SA2022/044

SUBDIVISION (4 LOTS)

RFI RESPONSE - SA2022/044 - 201,203 & 205 OLD BEACH ROAD, OLD BEACH & LOT 108 LEWIS COURT, OLD BEACH

Indicative Subdivision Plan

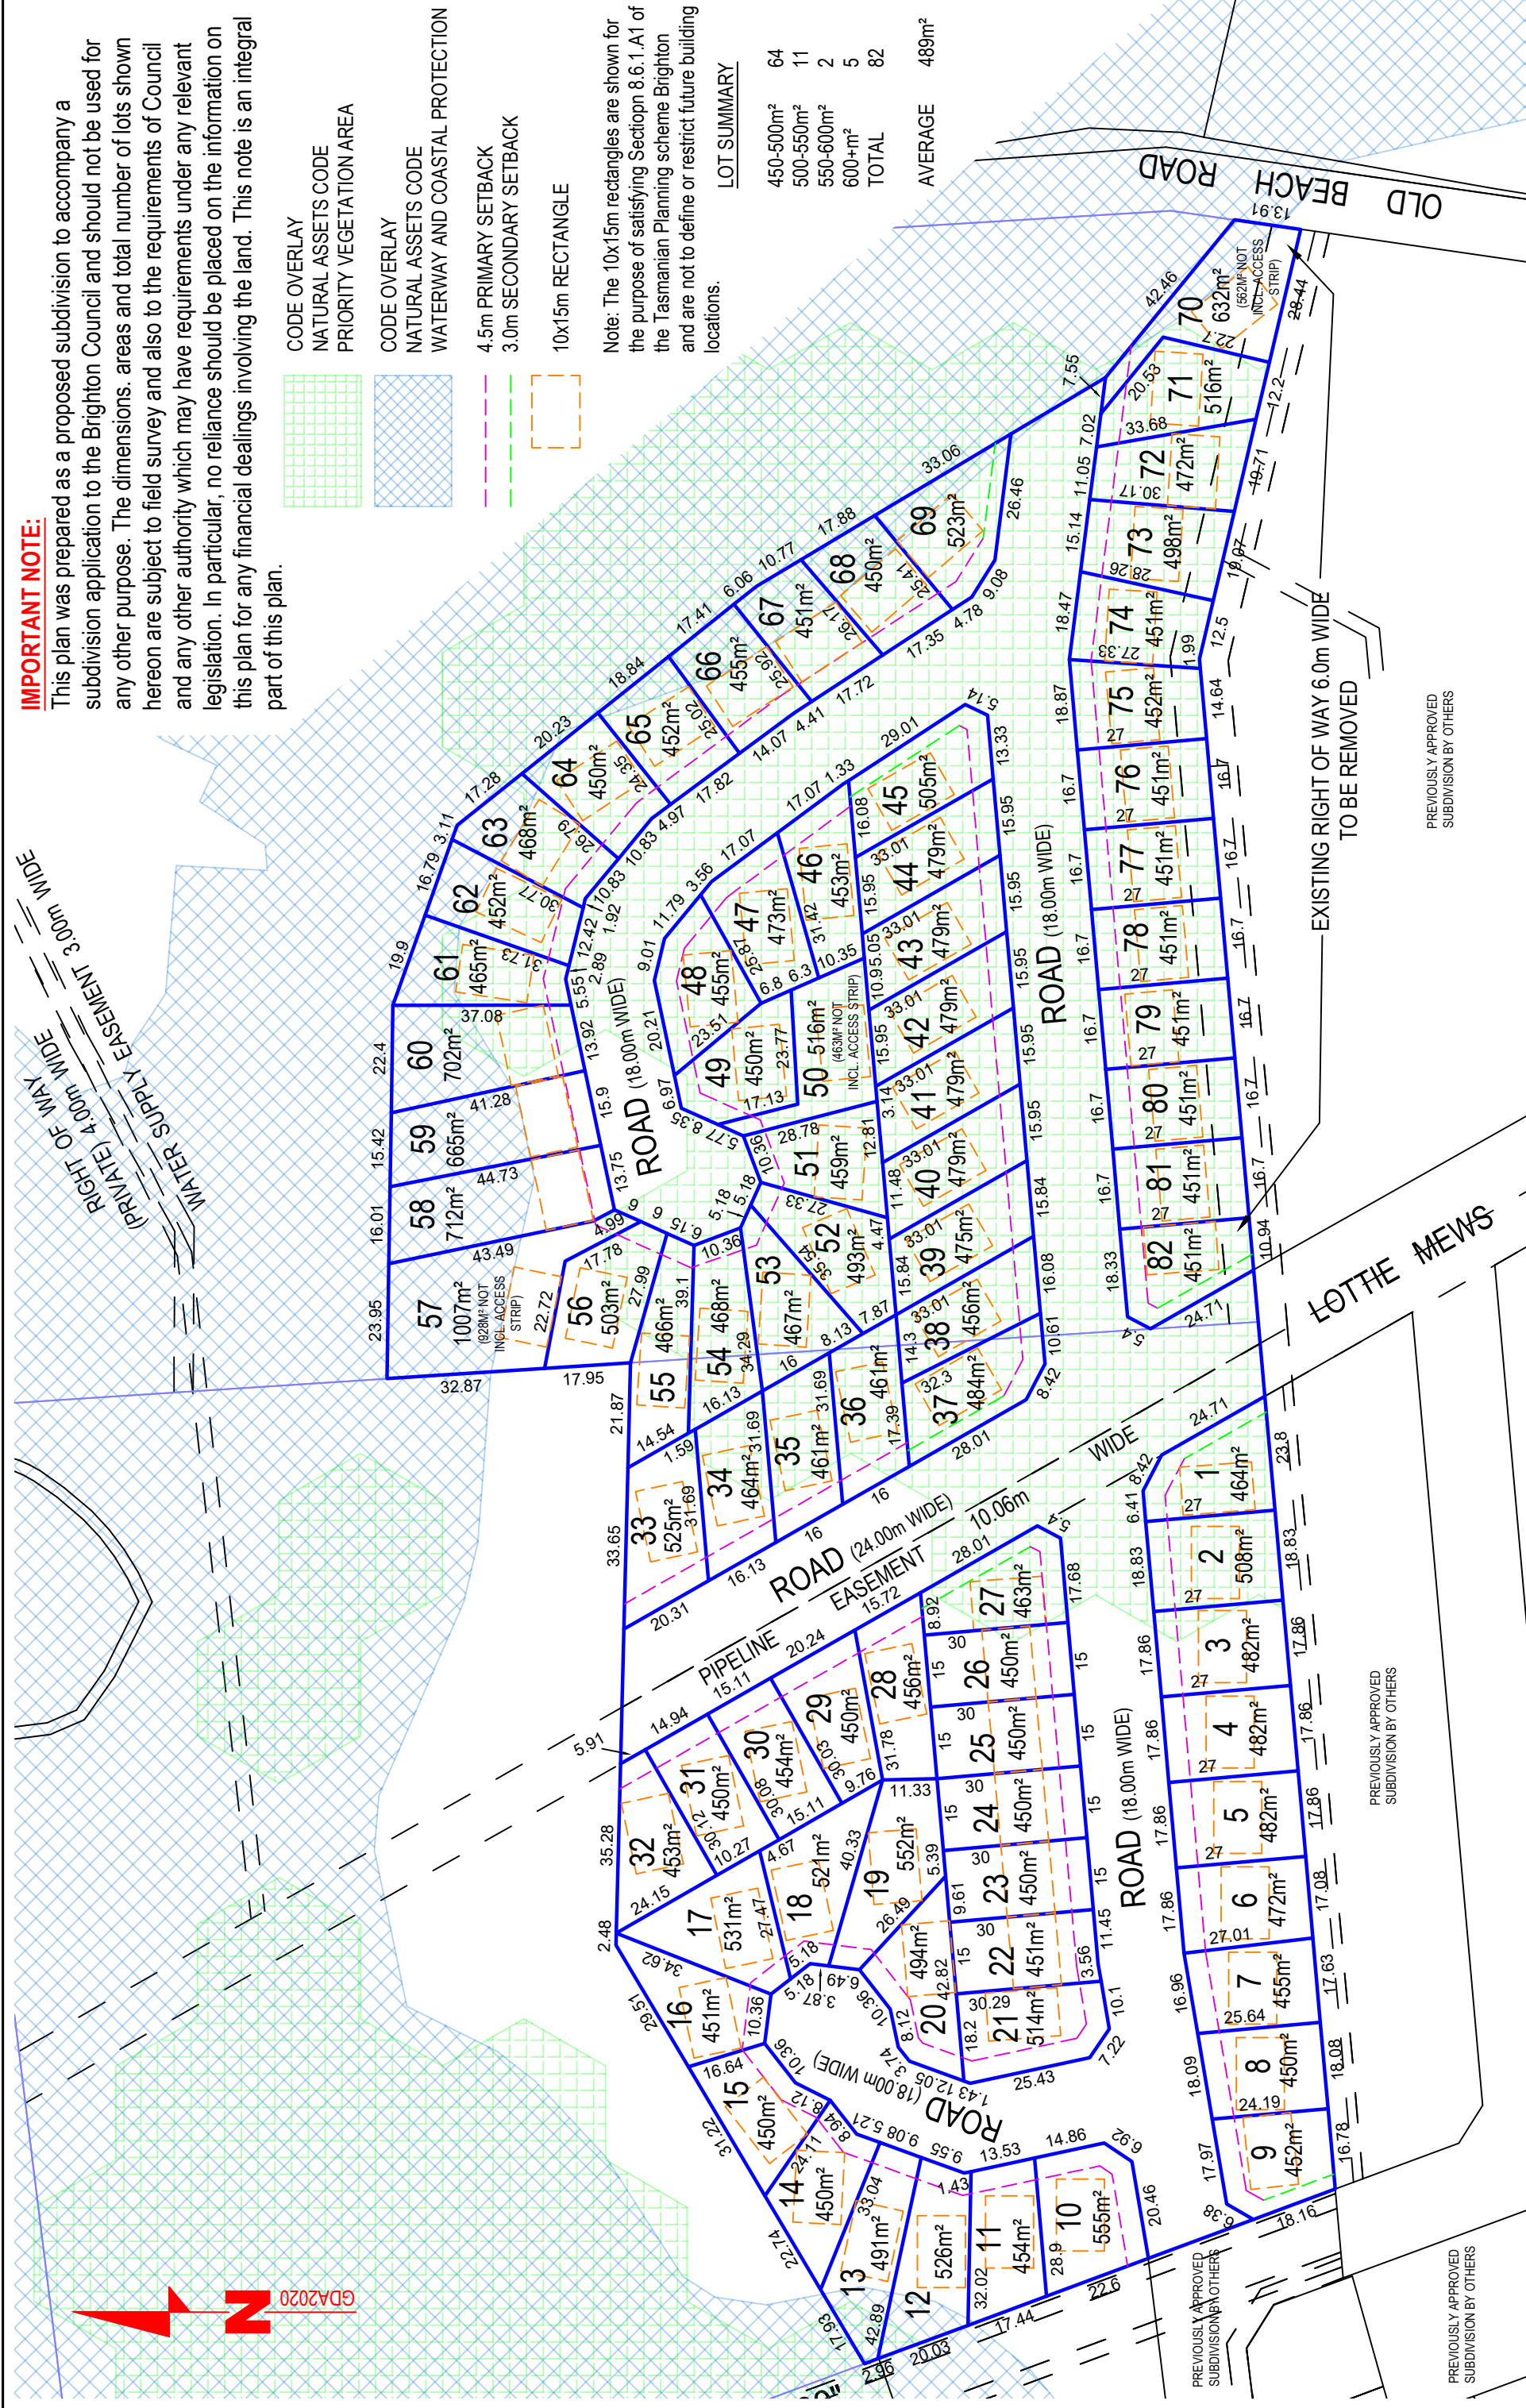
1. Future Subdivision Layout

An indicative lot layout for the residential subdivision is provided (Attachment 1), however, this will form part of an S33 application to the Council shortly.
